SECTION 009113 – ADDENDUM TWO

- A. Project Name: 22034.02 Meridian High School Additions, Renovations and Ballfield Rebid
- B. Owner: Meridian Public School District, 1019 25th Avenue, Meridian, MS 38391
- C. Architect: Dale | Bailey, an Association, One Jackson Place, Suite 250, 188 East Capitol Street, Jackson, MS 39201-2100
- D. Architect Project Number: 22034.02
- E. Date of Addendum Two: 12 January 2024

Meridian High
Baseball Field
E-201b
OVERALL POWER PLAN

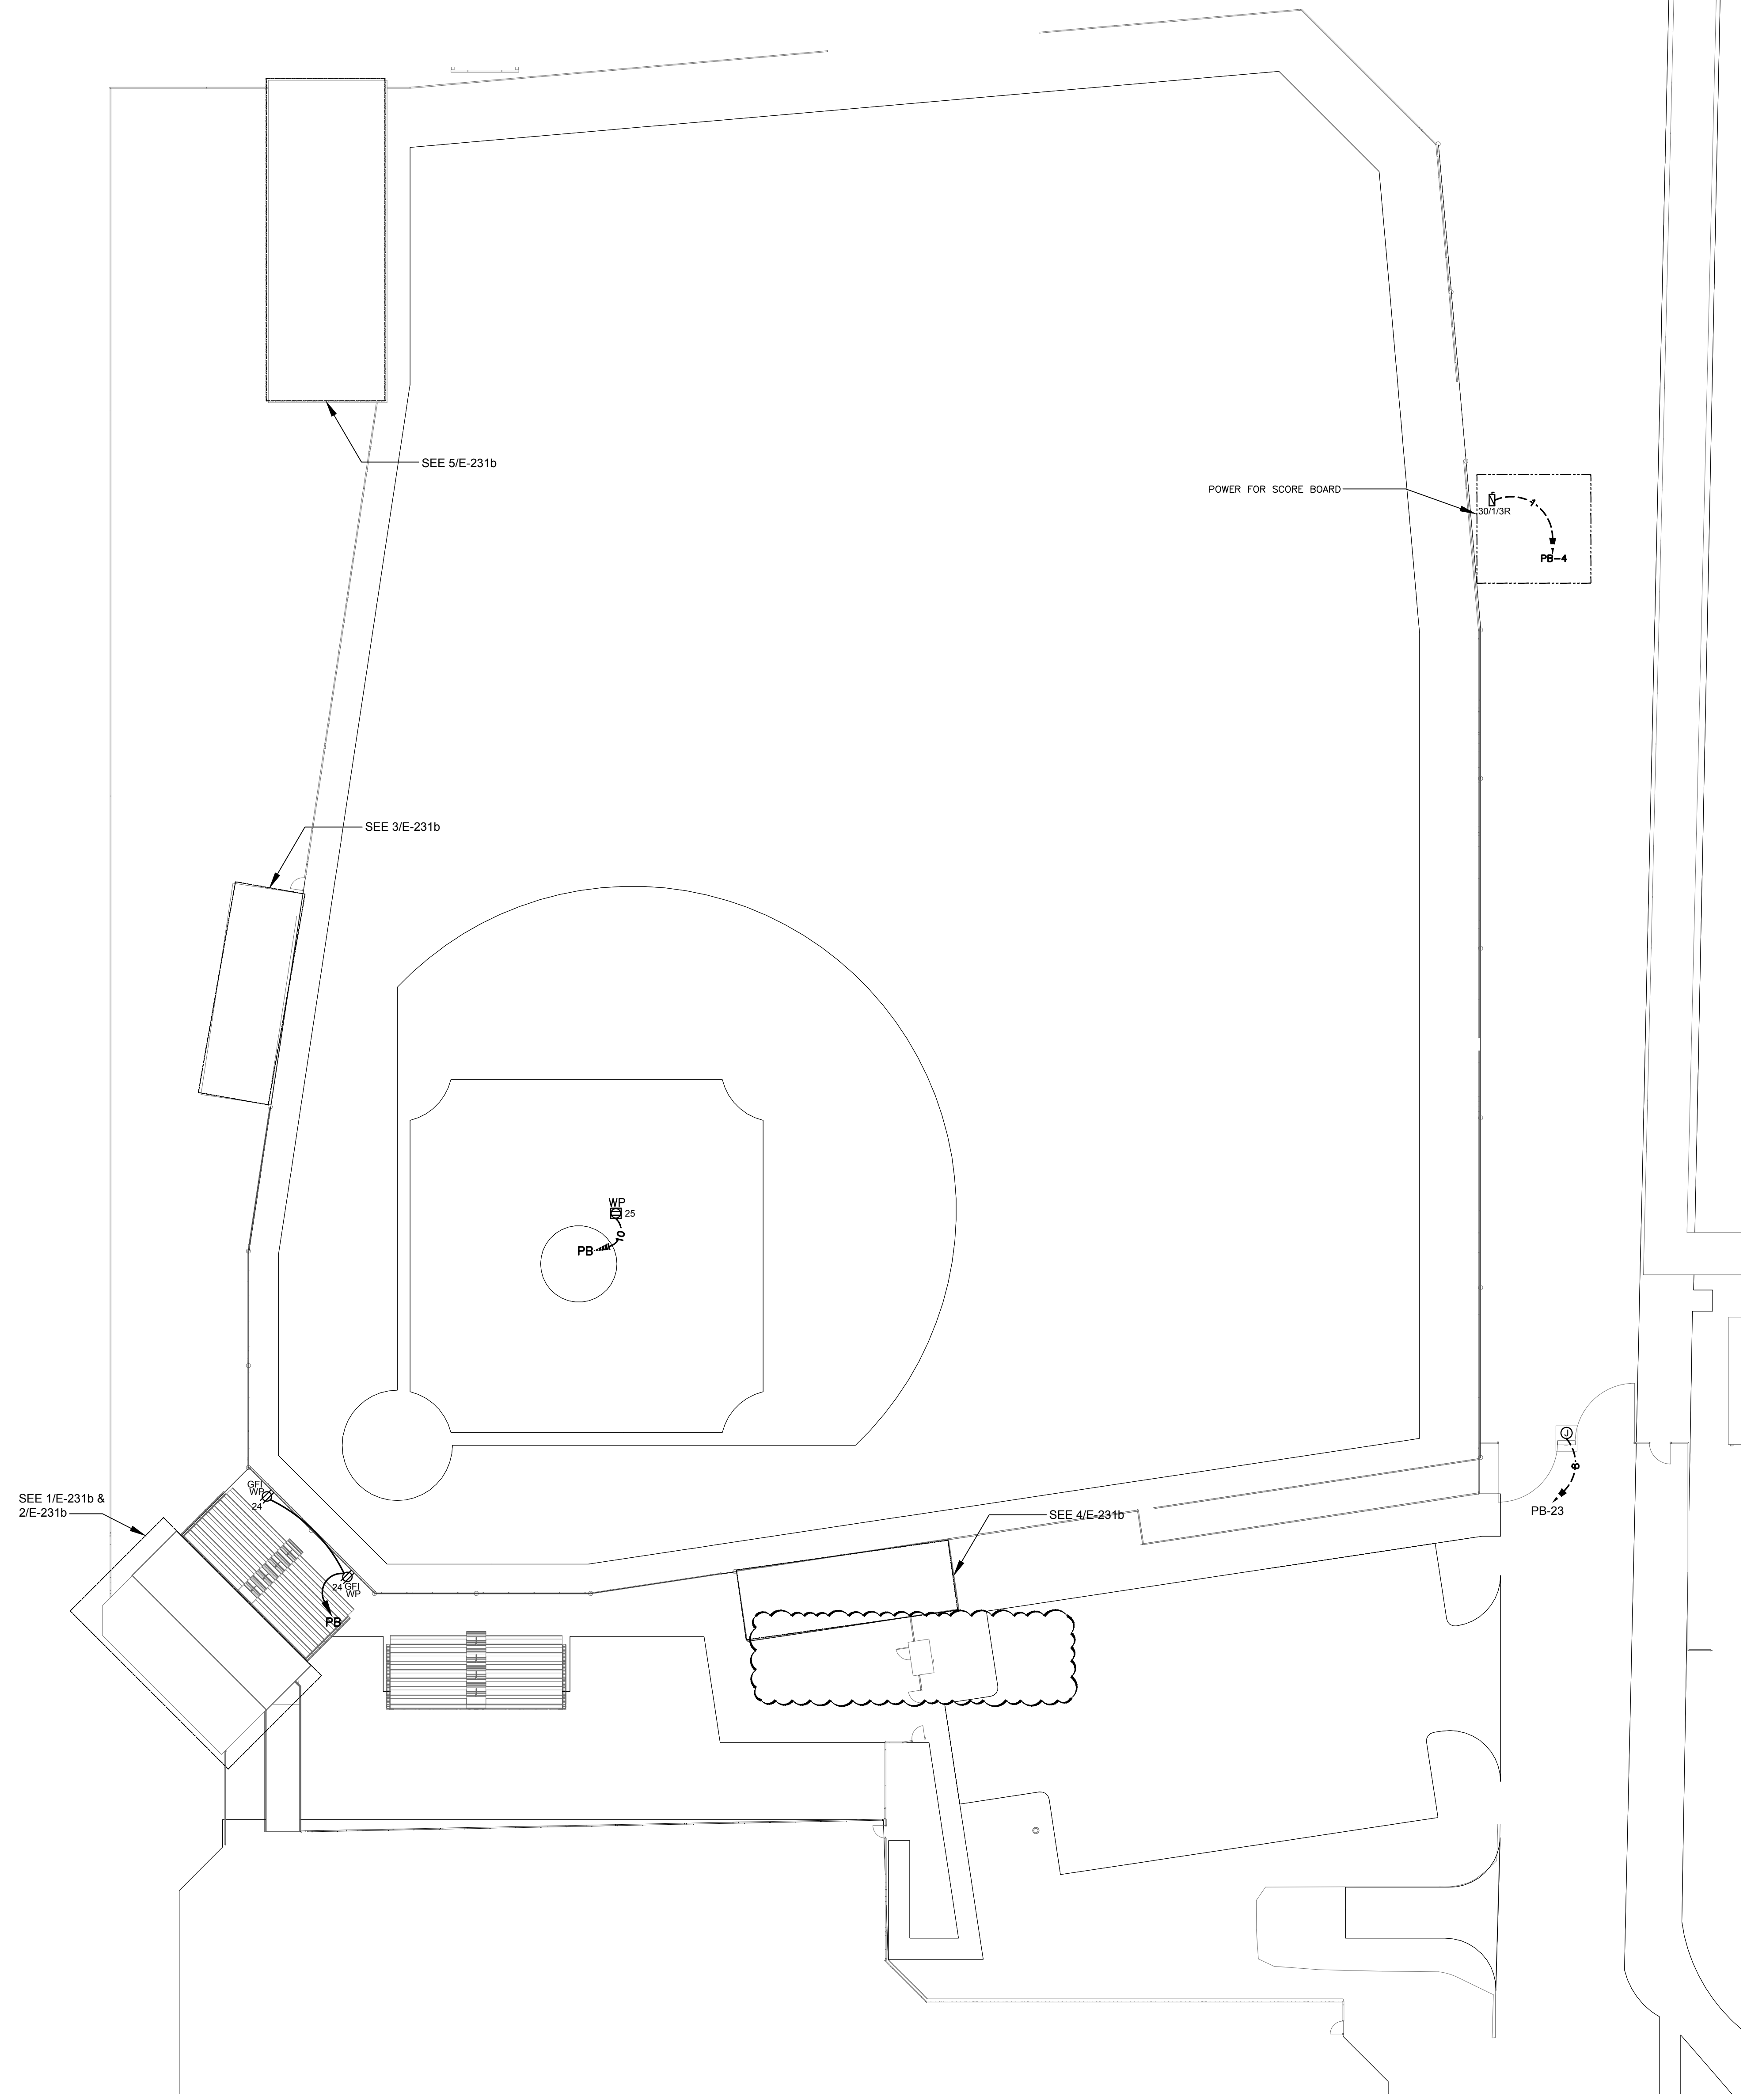
- A. Sheet AS101 – Architectural Site Layout (Revised). Added guard shack location and awning brick detail.
- B. Sheet A-491 – Restroom Details (Revised). Added quantities to toilet accessories..
- C. Sheet RC101 – Site Layout & Access (Revised). Corrected print issue and added clear temporary fencing layout for project.
- D. Sheet E-004A – Electrical Renovation Site Plan (Revised). Added power for modular building.
- E. Sheet E-201B – Overall Power Plan (Revised). Deleted power for modular building.
